RE: COST OF STORMWAER DRAINAGE IN THE MAMRE ROAD PRECINCT  
SUBMISSION TO IPART

This letter has been prepared by [REDACTED], and outlines a response to the Issues Paper released by the Independent Pricing and Regulatory Tribunal (IPART) titled '*Cost of stormwater drainage in the Mamre Road Precinct*' (23 April 2024). The objective of this submission is to outline general key concerns relating to the cost of regional stormwater scheme infrastructure planned by Sydney Water, and to provide advice and recommendations for the consideration of IPART.

**RE: WESTERN SYDNEY AEROTROPOLIS STORMWATER  
DRAFT AEROTROPOLIS STORMWATER MANAGEMENT FRAMEWORK AND DRAFT SCHEME  
PLAN FOR MAMRE ROAD PRECINCT  
SUBMISSION ON BEHALF OF MAMRE ROAD LANDOWNERS GROUP**

Figure 1: Extract from Innovative water management for the Aerotropolis Precinct (Sydney Water, May 2022)

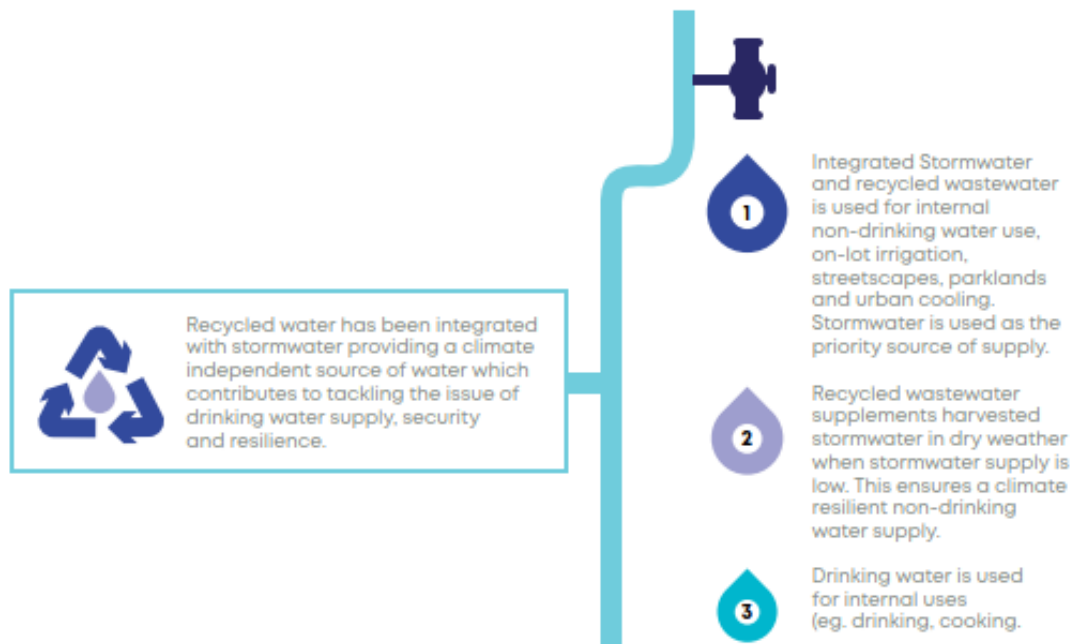
As an interim measure (prior to delivery of the regional scheme and reticulated recycled water network), development in the MRP can satisfy the non-potable reuse targets outlined in the DCP by connecting to irrigation tank that would harvest roof runoff from warehouses for reticulation to toilets and landscape irrigation systems. In addition, this tank would be sized to capture runoff for evaporative roof irrigation (misting, drip or thin-film irrigation), such that part of the MARV reduction required in the DCP could be achieved.

Once the regional stormwater management scheme and reticulated recycled water network is delivered, developments that rely on rainwater tanks for non-potable reuse would be switched to the recycled water network. The on-lot tanks would be retained for the purpose of roof water capture for evaporative irrigation, which would continue to contribute to the stormwater flow targets in the MRP.

This approach is consistent with Sydney Water’s intent to deliver an integrated stormwater and recycled wastewater system.
